Plan Commission

Special Meeting

Agenda

Monday, May 16, 2016	5:30 PM	De Pere City Hall Council Chambers
-----------------------------	----------------	---

102 N. Broadway
Approved South Elevation – September 2015

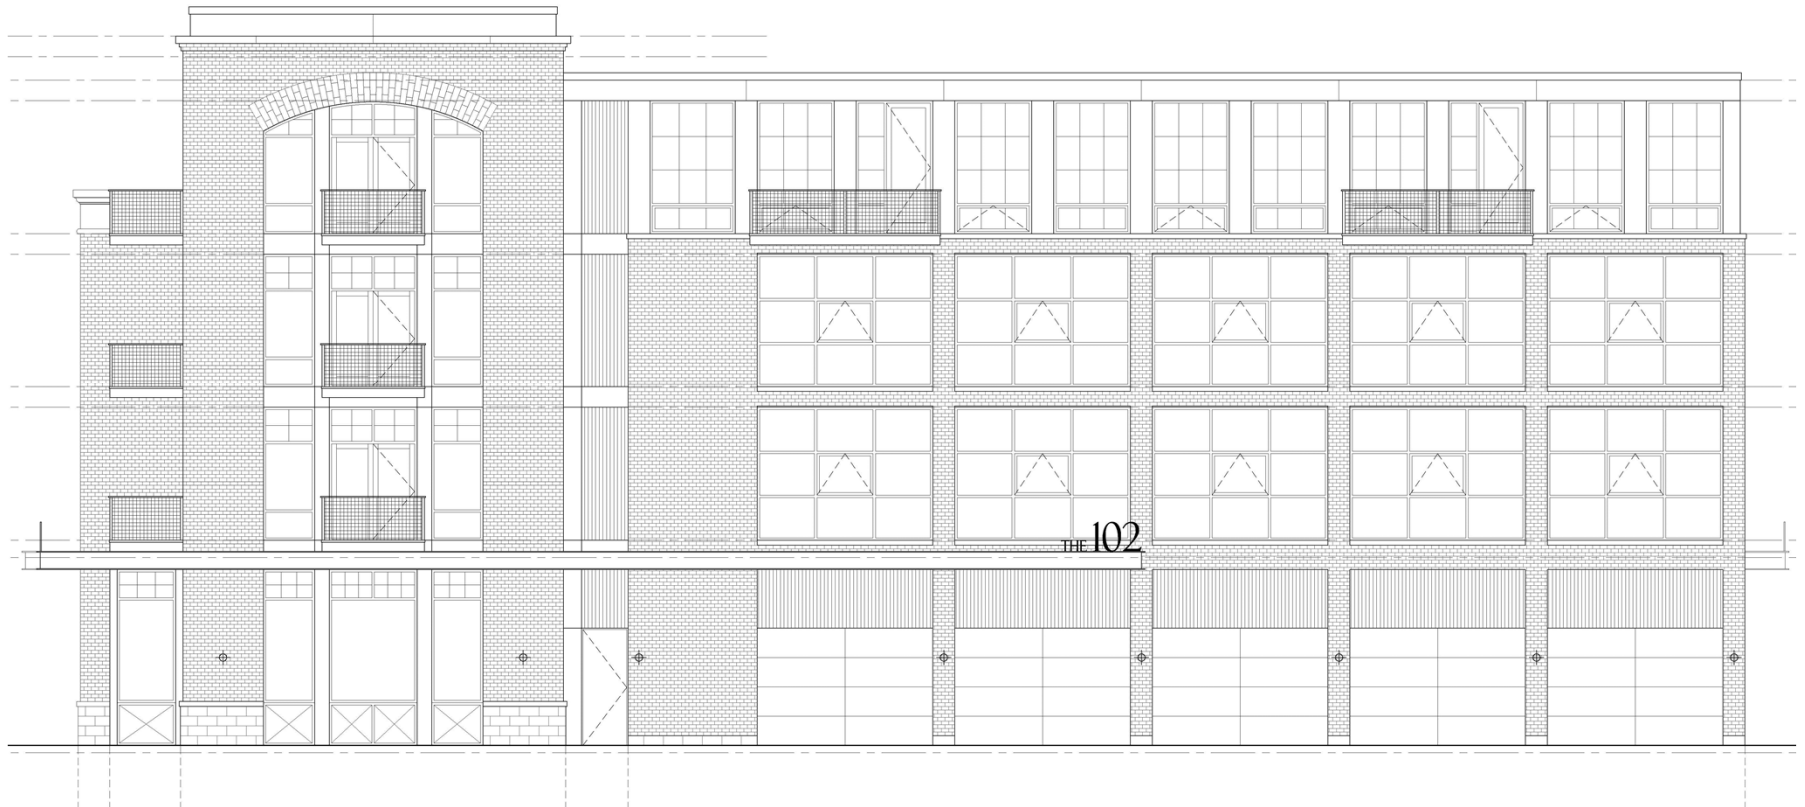
- Metal panel color has been adjusted to reflect a warmer tone.
- Decorative masonry details (Quoins) have been added along the columns of the building.
- The metal panels between the windows along the 'bump out' portion of the façade have been changed from a tan color to a dark brown. Cornice brick corbeling has also been added in this area.
- Additional masonry details have been added to the base of the pier at the southwest corner.
- The top floor includes a decorative coping feature. The design of the metal panels on the top floor has been revised to emulate more of a flat stone running bond pattern.

102 N. Broadway
Proposed North Elevation – April 2016

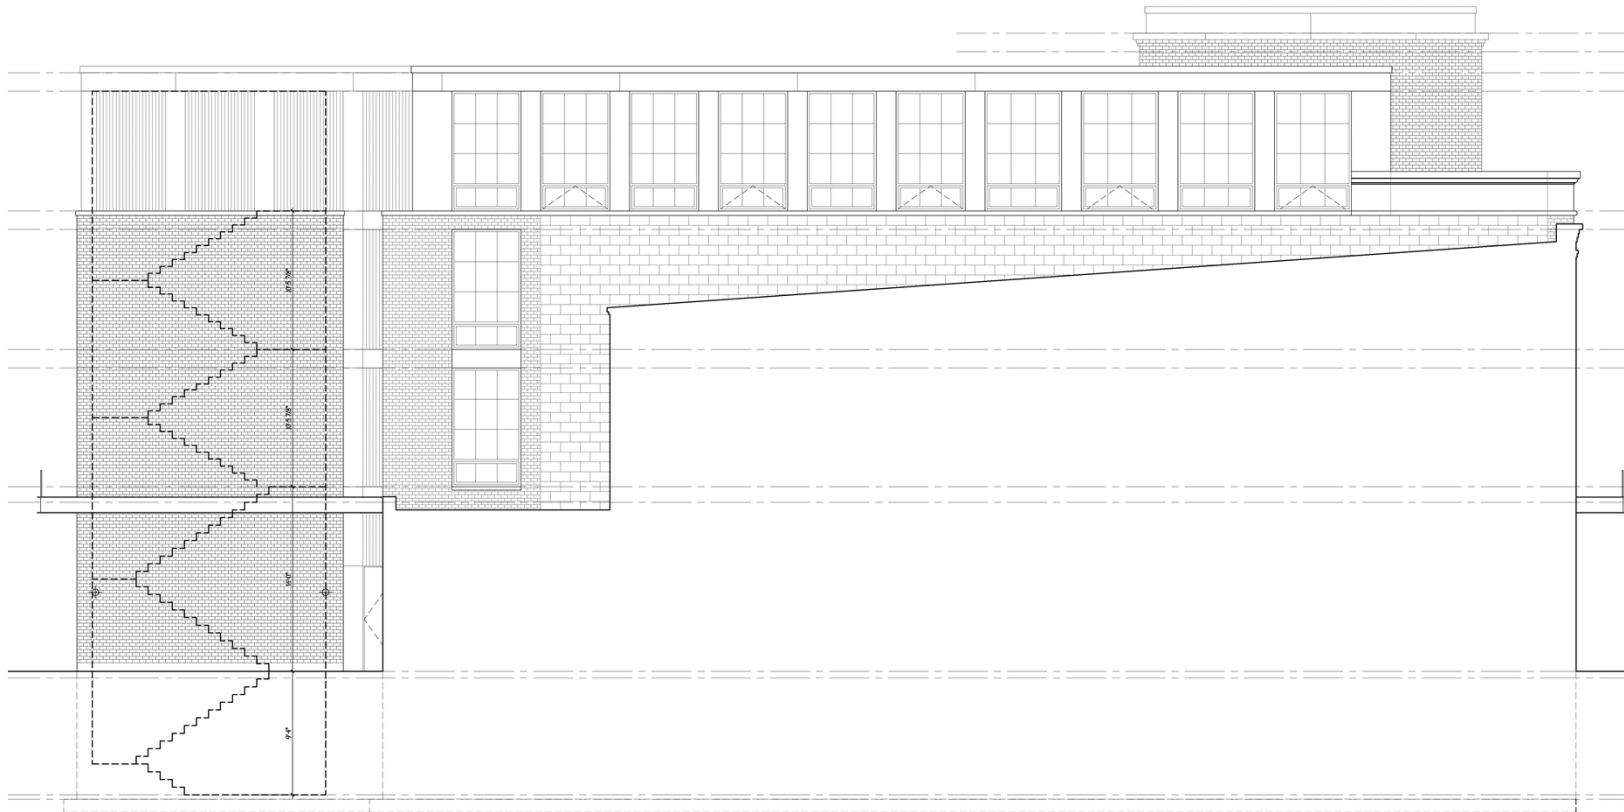
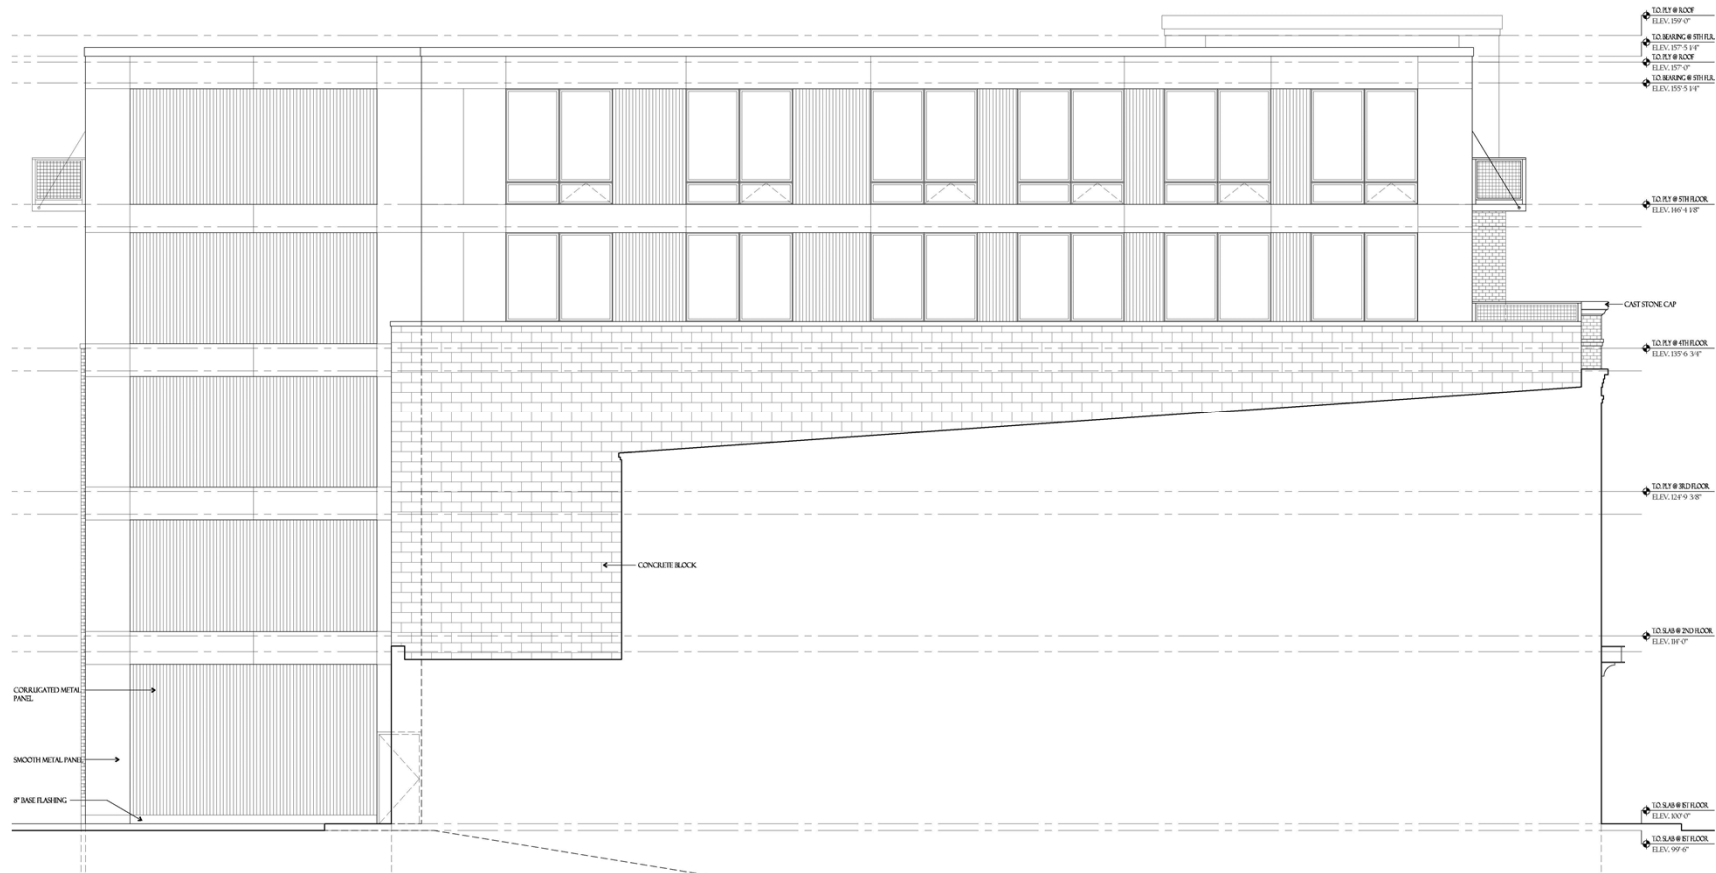
- Metal panel color has been adjusted to reflect a warmer tone.
- Decorative masonry details (Quoins) have been added along the columns of the building at the southwest corner.
- Additional masonry details have been added to the base of the piers at the southwest corner.
- The southwest corner of the top floor includes a decorative coping feature. The design of the metal panels on the top floor has been revised to emulate more of a flat stone running bond pattern.

SITE AND UTILITY PLAN

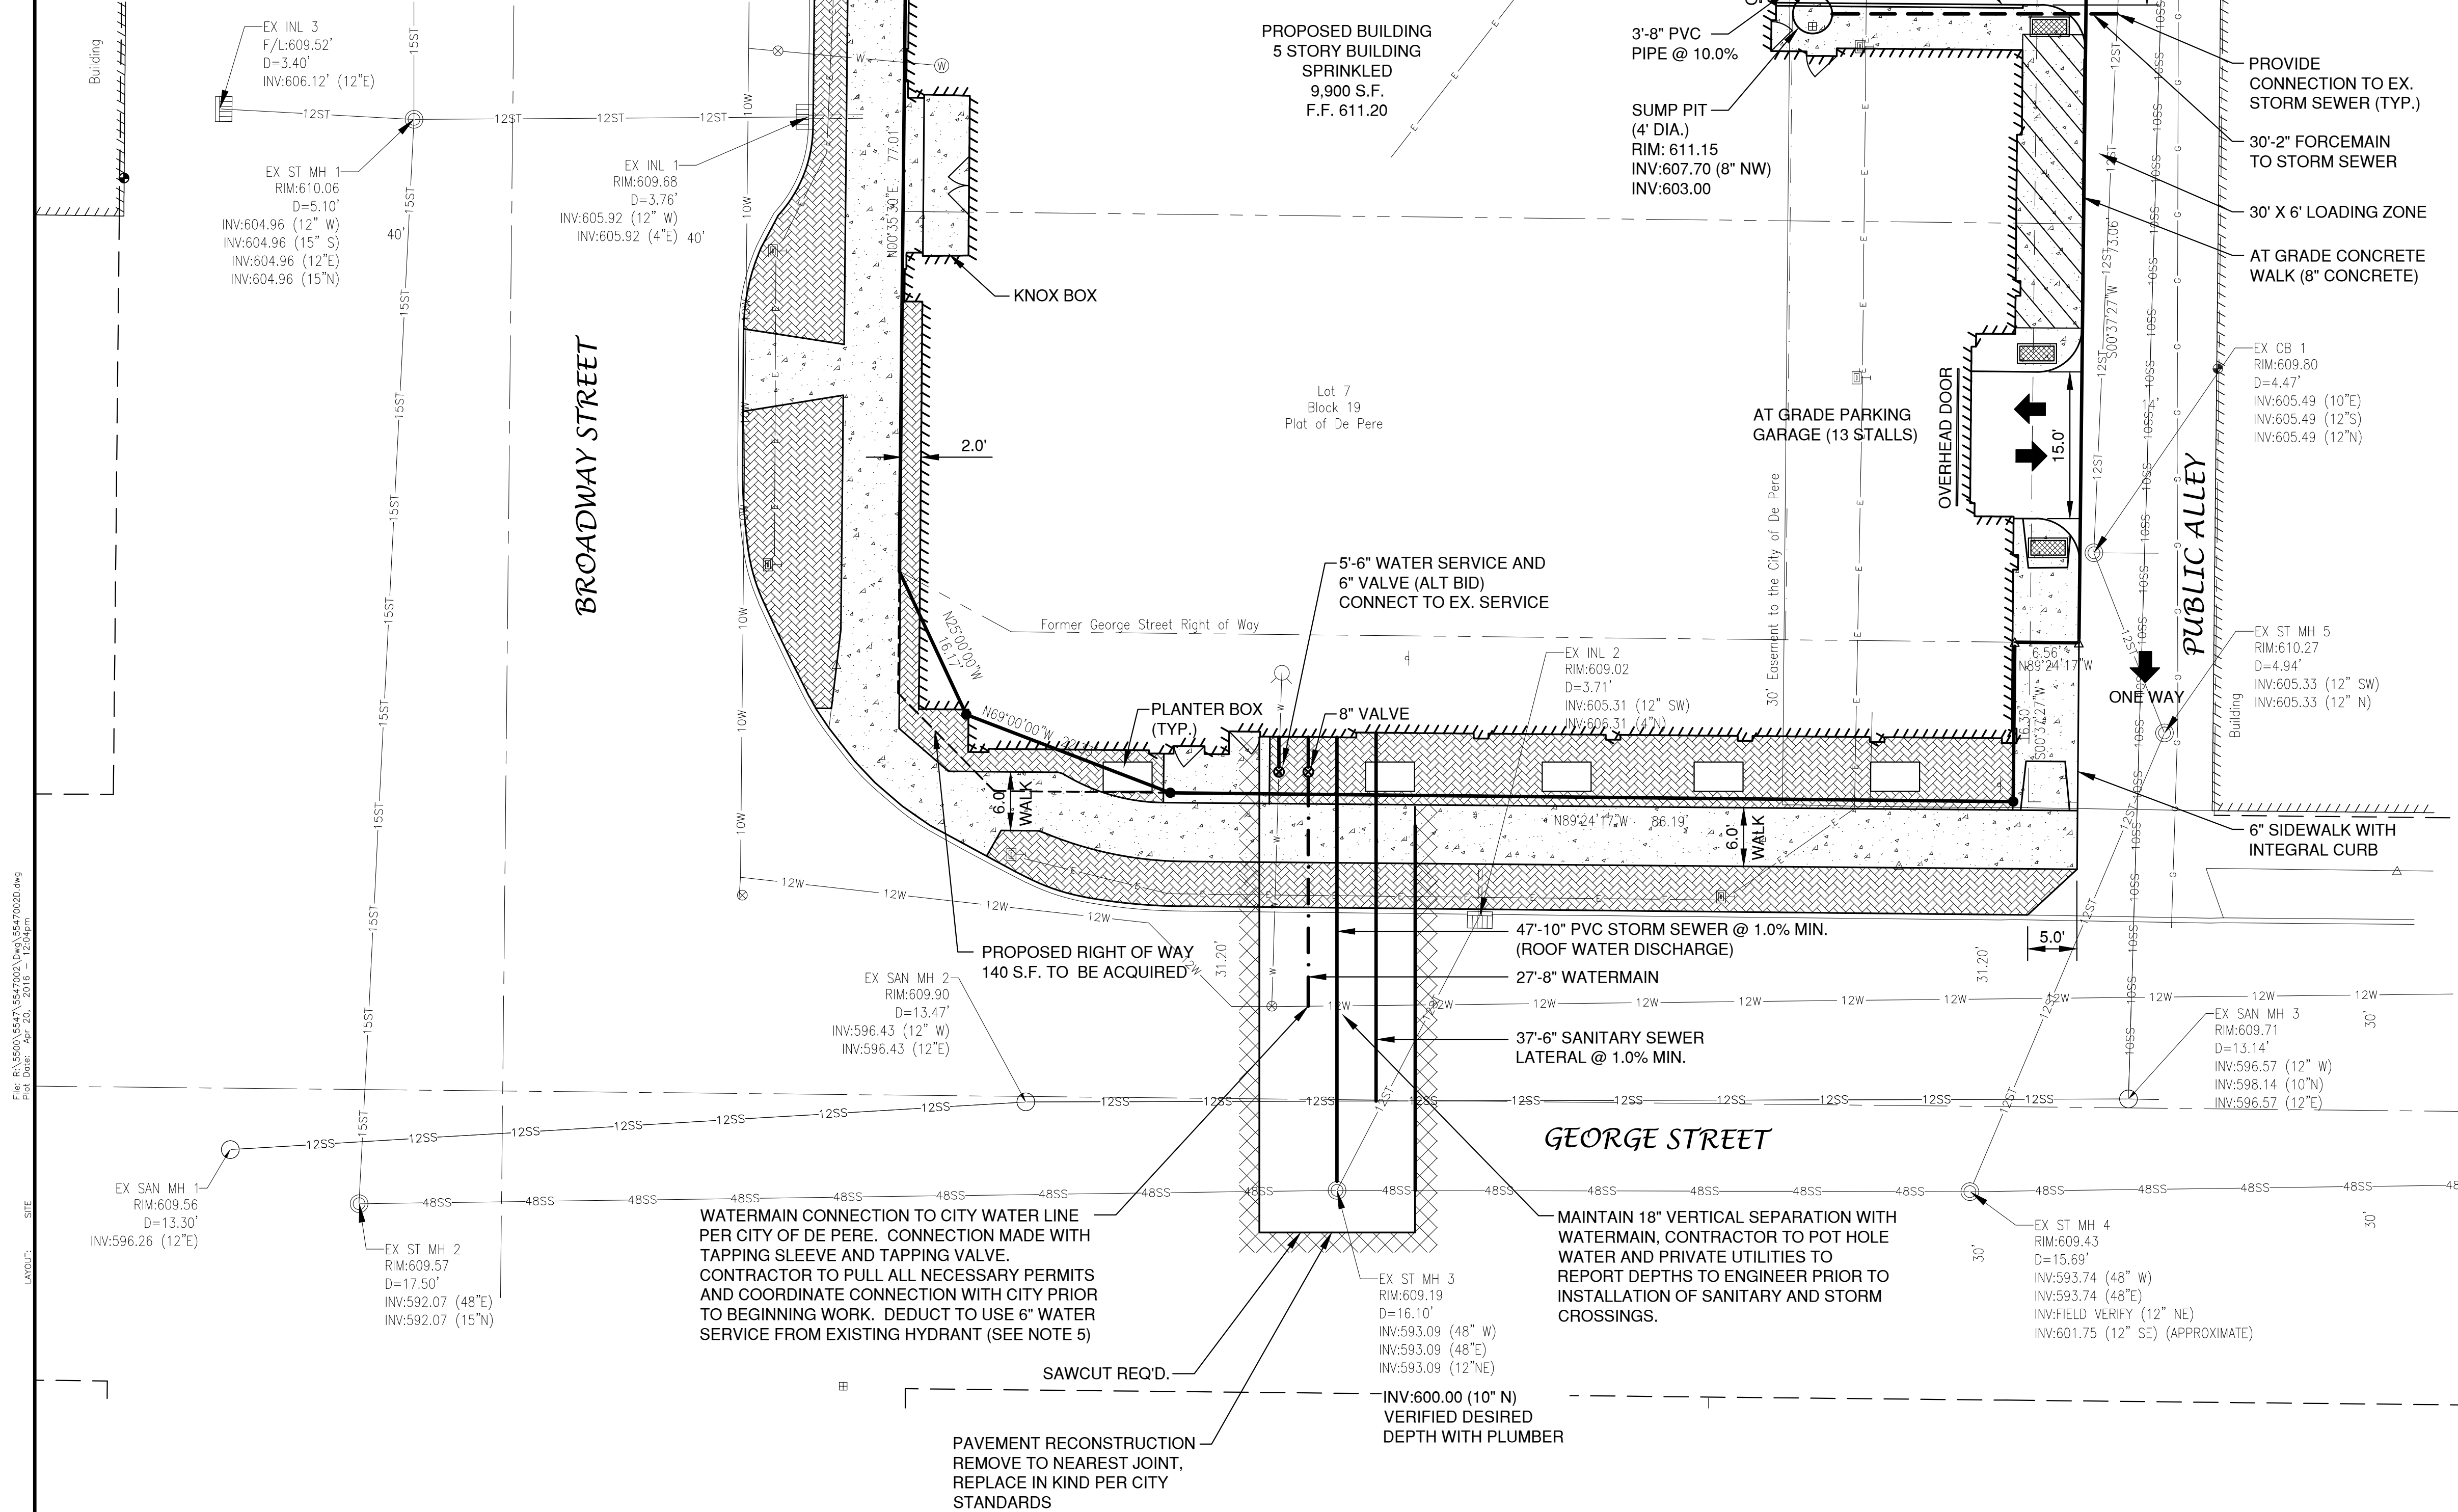
3. Two storm sewer connections are shown on the plan. One connection should be evaluated for maintenance purposes. Provide storm sewer calculations for the site to quantify the runoff to the City storm sewer from this development. The existing storm sewer in the alley has limited capacity. A relay of this pipe may be required or the City may consider a direct connection to the George Street storm sewer. Show the existing utilities on the plan.

8. Show mailing address of developer/owner and architect on the plan.
9. Water service to the property is shown as 8" connecting to the City 12" water main on George Street. Note on the plan that this connection will be made with a tapping sleeve and tapping valve. Provide documentation that the 8" pipe is needed to serve this development. The hydrant on George Street has been relocated by the City of De Pere. Water meters larger than 1" will require one month advance notice.

13. A 6" sanitary lateral is shown connecting to the City's 12" sanitary sewer on George Street. Show the 12" City sanitary sewer main extending to the east into SAN MH 3 on the plan. Make the connection using Saddle Connection and Wye as recommended by the manufacturer.
